TOWNSHIP OF BERKELEY
ZONING BOARD OF ADJUSTMENT
REGULAR MEETING AGENDA
MARCH 13, 2013
6:30 PM PUBLIC HEARING

Re: **BOA #12-5405**
Applicant: Joseph Semanchik
215 Butler Boulevard
Application: To Construct a Solid 6 Ft. High Fence
Between the Rear Building Line and Bulkhead
Block 1541, Lot 65
Fronting on Butler Boulevard
Zone: R-64 Zone
EE & L Project No. 12B4533-7S03

Re: **BOA #12-5417**
Applicant: Anthony & Debralee Marchese
Application: Construction of an Inground Pool
within the Front yard Setback on a Corner Lot
Block 285, Lots 13-18
Fronting on Bradford Pl. with Frontages on
Columbus Circle & Hanover St.
Zone: R-150
EE & L Project No. 12B4533-7M07

Re: **BOA #13-5422**
Applicant: Robert & Marie Crespi
Application: Construction of an Inground Pool
on an Undersized Lot with Side & Rear
Setback Variances
Block 1617.02, Lot 7
Fronting on: Cedar Run
Zone: R-64
EE & L Project No. 12B4533-7C07

Aerial Photo from Google Earth (9/20/10) Modified by RVV to show approximate location of the proposed pool.

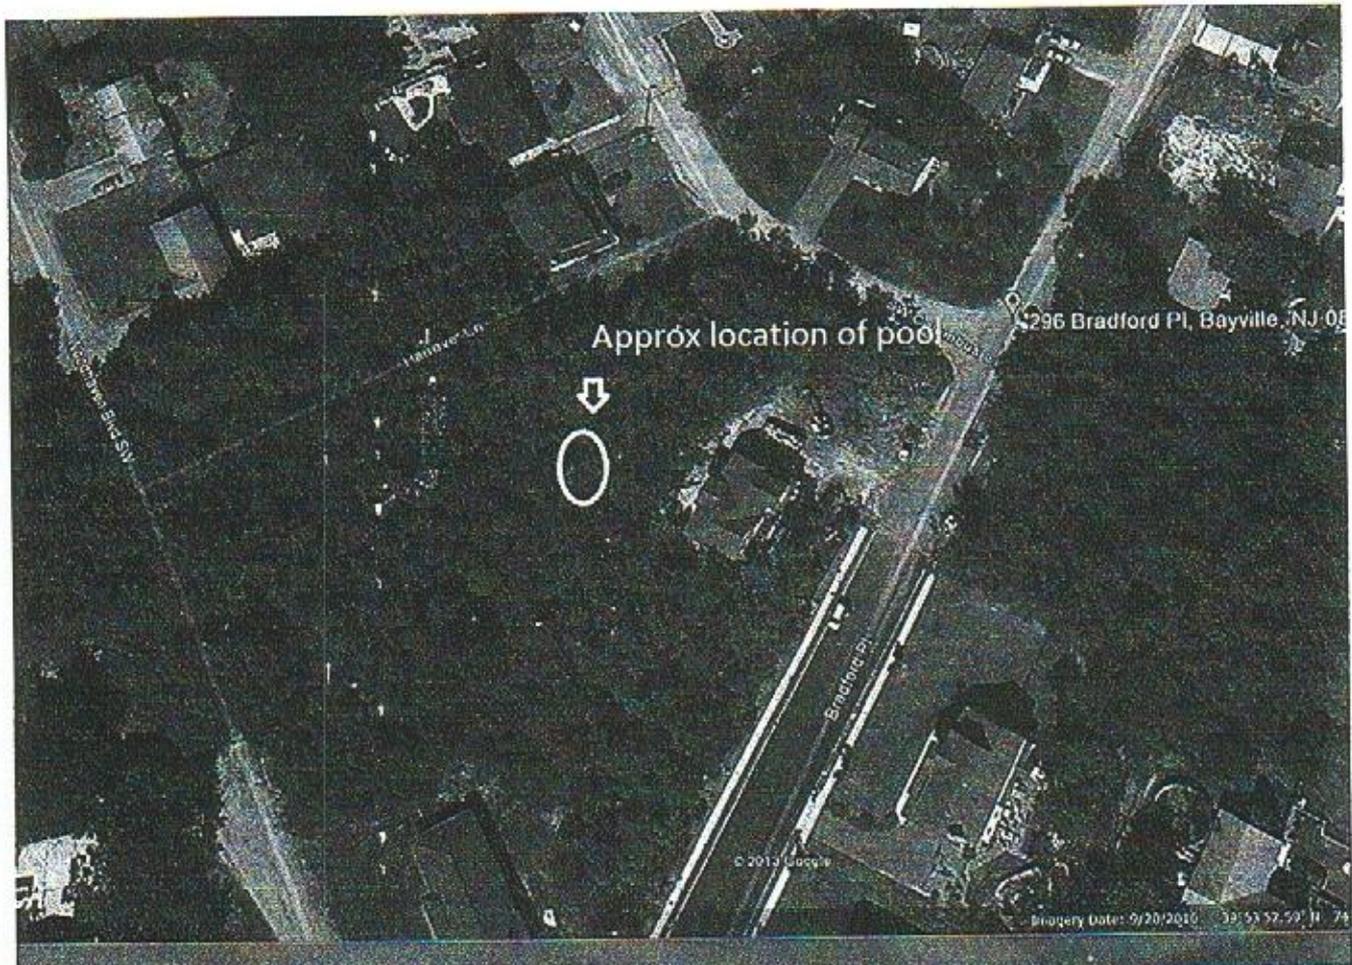
The applicant is proposing to install a 16' X 32' inground pool in the front yard area of a corner lot. The subject parcel fronts on three different streets, Hanover Street, Columbus Circle and Bradford Place. The home faces Bradford Place. Hanover Street is an approximately 50' wide unimproved right-of-way, which is heavily wooded at the present time. The applicant is proposing to locate the proposed pool 7 feet from the property line, which is presently fenced with a six (6) foot vinyl privacy fence. The front yard setback requirement off of Hanover is 35 feet. It should be noted that immediately to the north, the property that would be on the other side of Hanover faces Columbus Circle.

1. The applicant should be prepared to provide testimony describing the proposed location and size of the pool. The pool is located 7 feet from the property lines.
2. The applicant should be prepared to provide testimony regarding any proposed patios or decks, and their relation to the setbacks, if any.
3. The applicant should be prepared to provide testimony regarding the reason that the pool cannot be located closer to the home, within the setback.
4. The applicant should be prepared to discuss whether or not the location and size of the pool will affect any drainage on the site, or adjacent properties.
5. It may be advisable that the pool be located a minimum of ten (10) feet from the property line, so that the pool and patio are located completely outside of the 6 foot shade tree and utility easement, should Hanover Street ever be improved.
